Board of County Commissioners • Escambia County, Florida

ADDENDUM NUMBER 1:

Re: PD 17-18.067 Pensacola Beach Sign Frame Replacement

Drawing S-4: FRAMING ELEVATIONS, COLUMN LAYOUT, AND BASE PLATE DETAIL

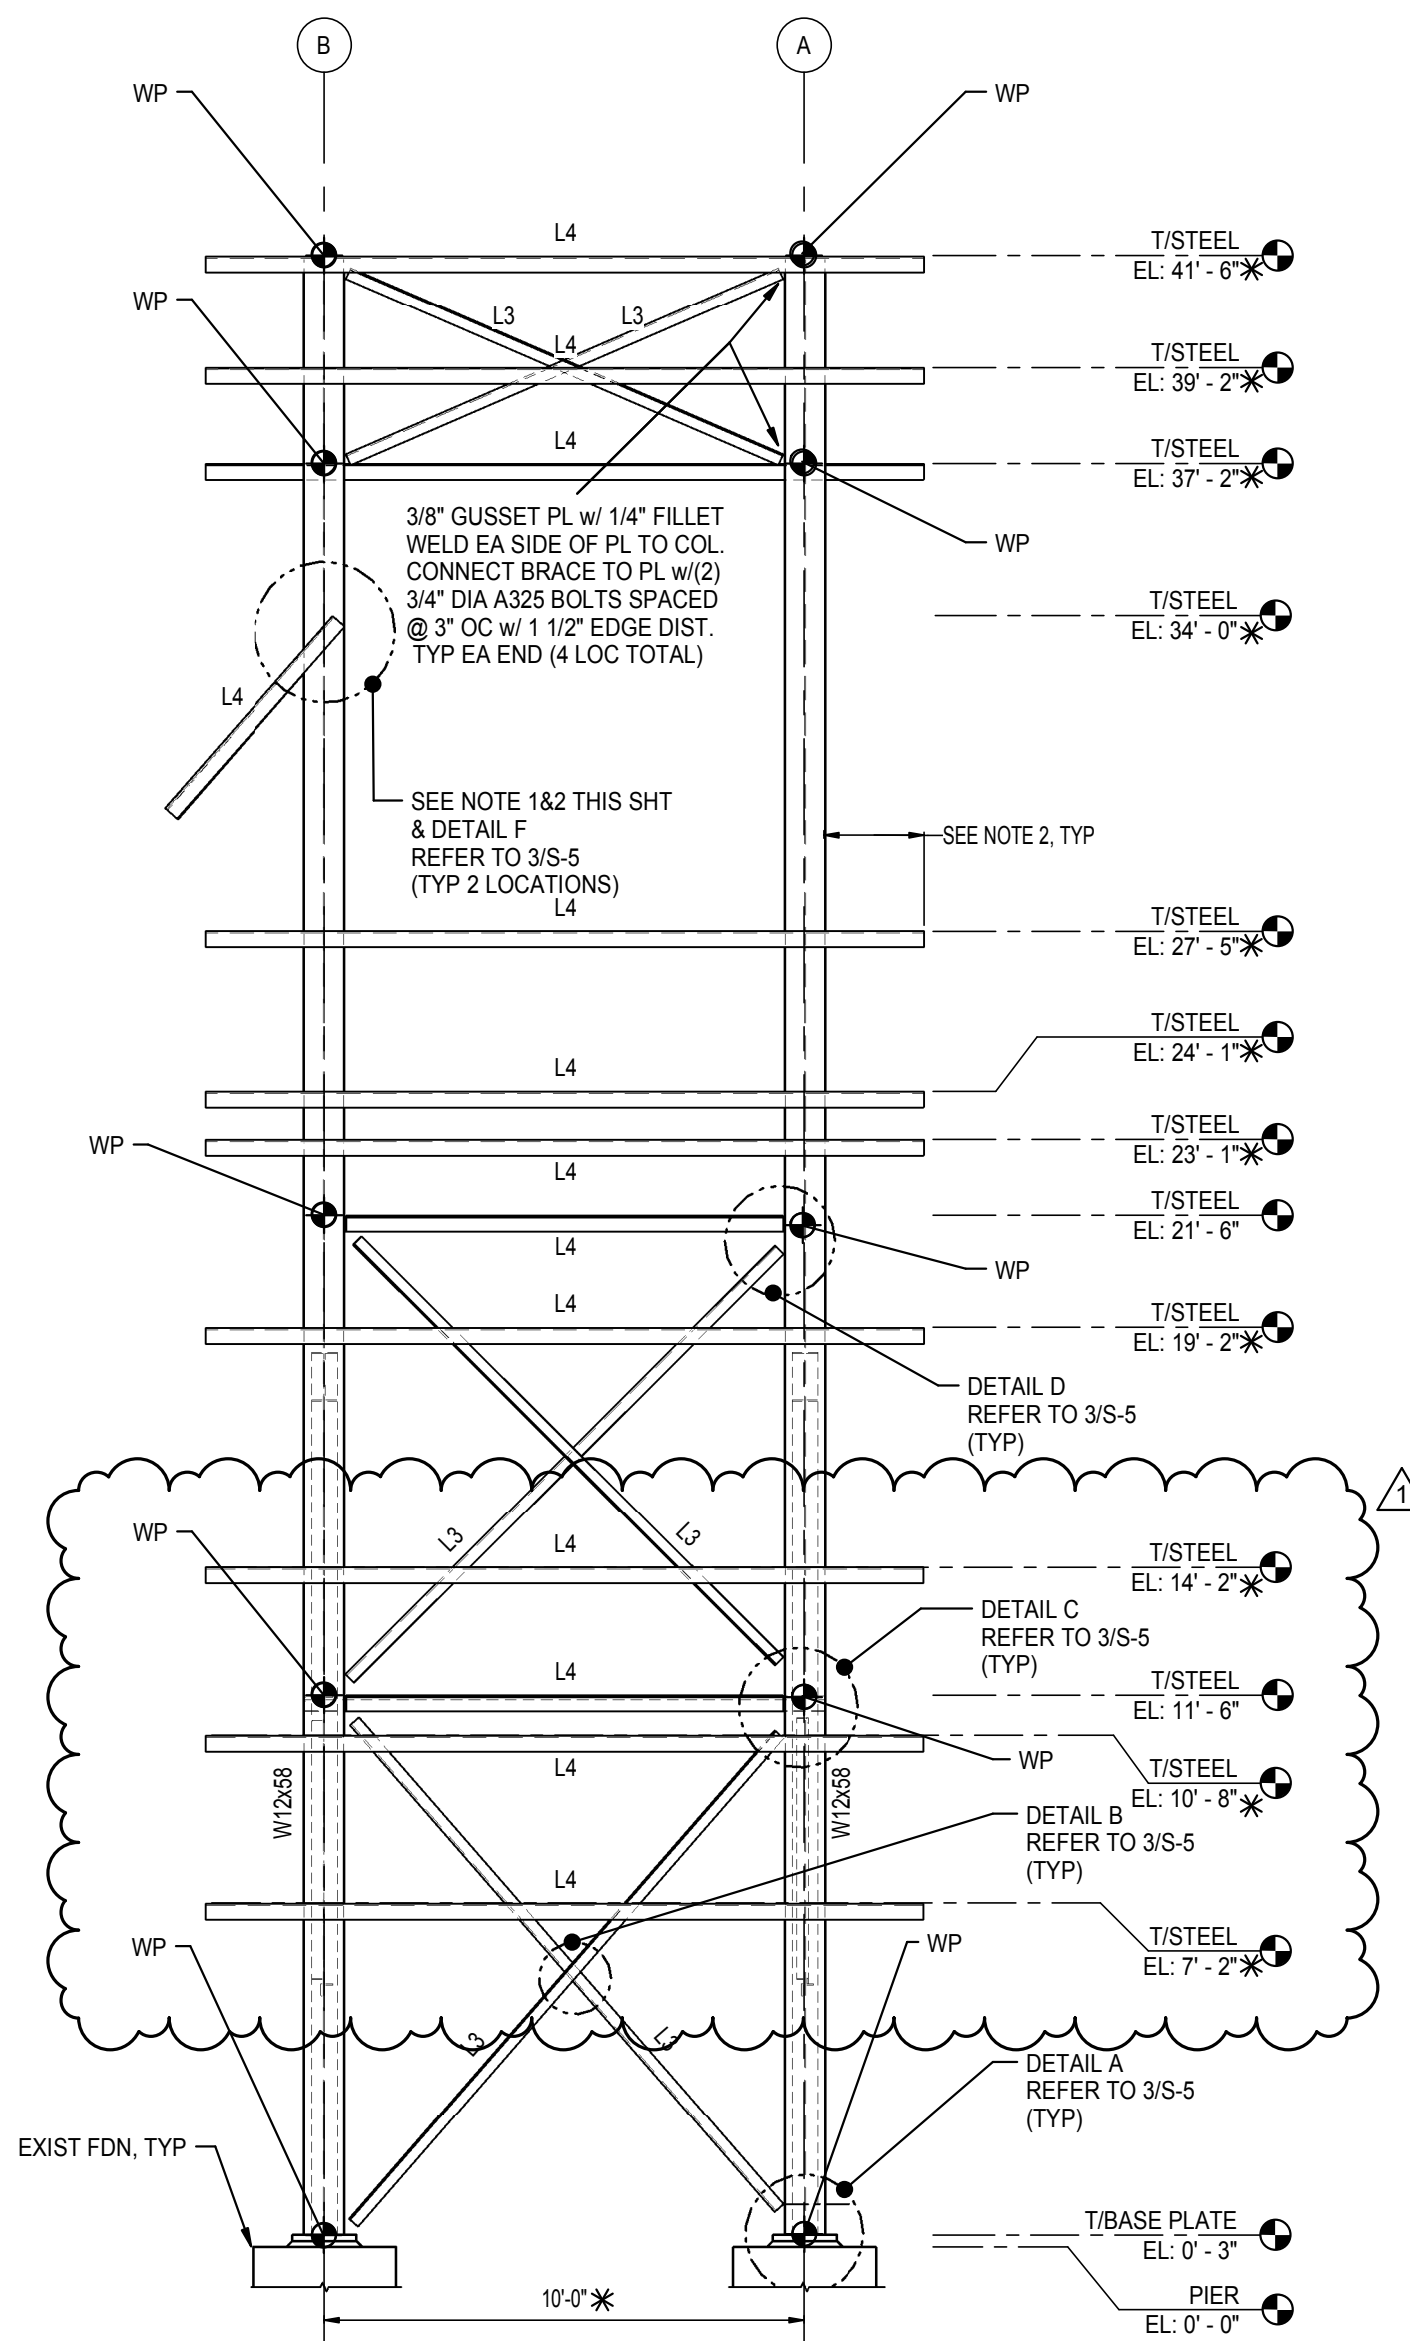
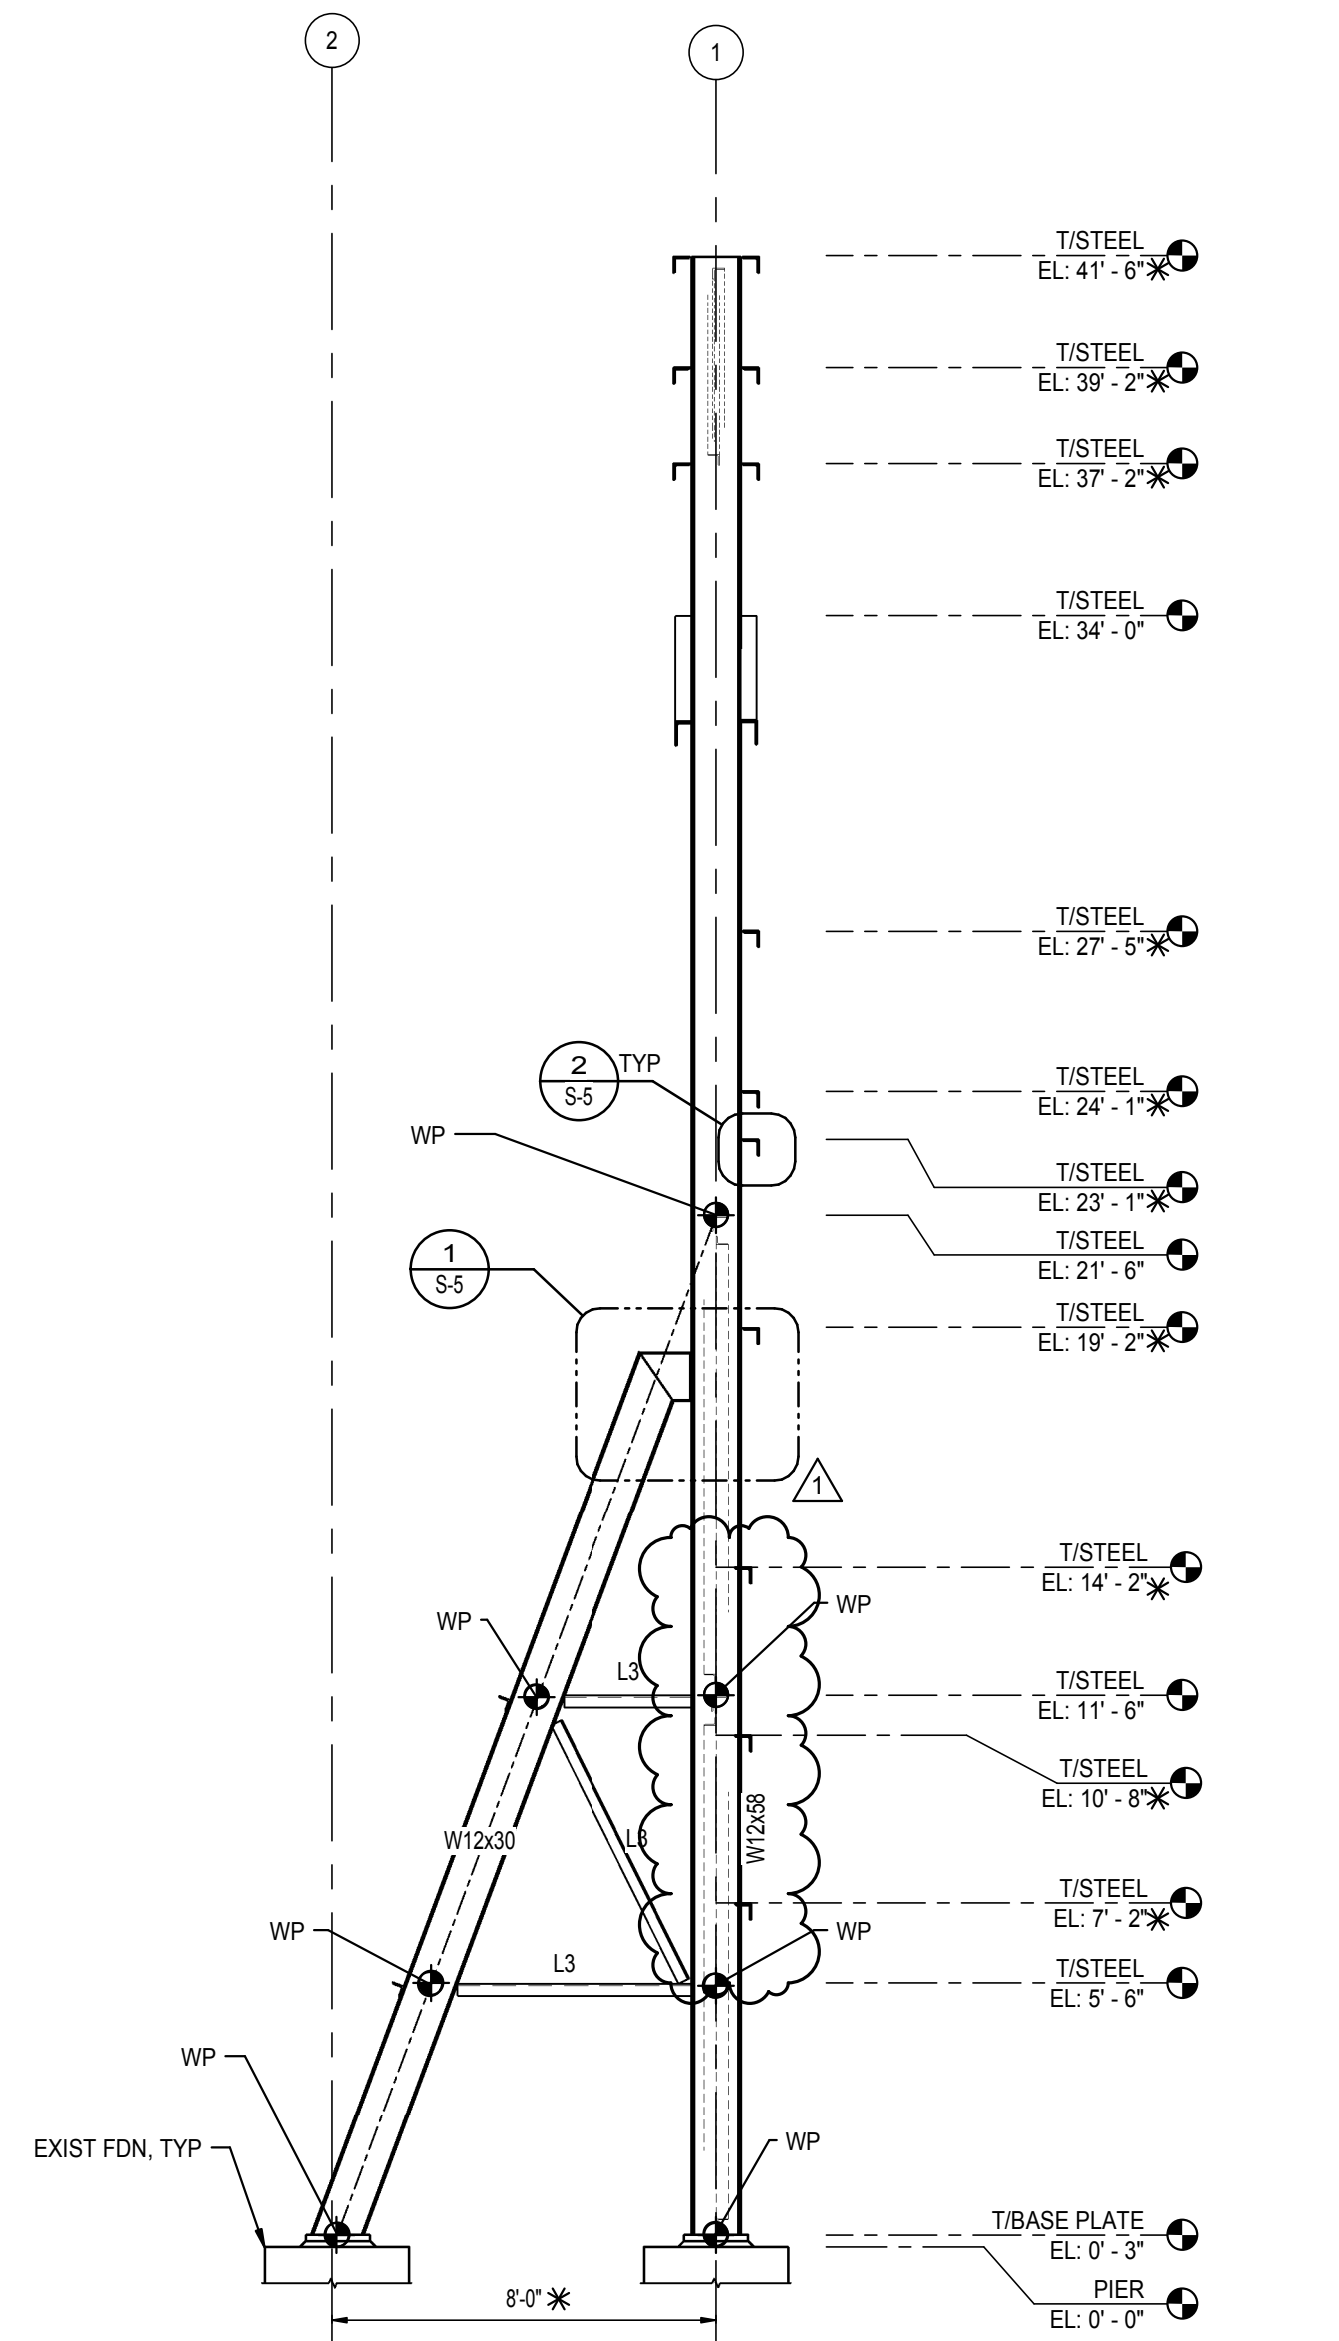
1. Refer to the attached drawing S-4 for framing revision at bottom sign. Provide (3) L4x4x3/8 angles for bottom sign. Elevations and length shall be coordinated with new bottom sign and field measurements. Connections to match those proposed for middle and top signs and as shown on 2/S-5.
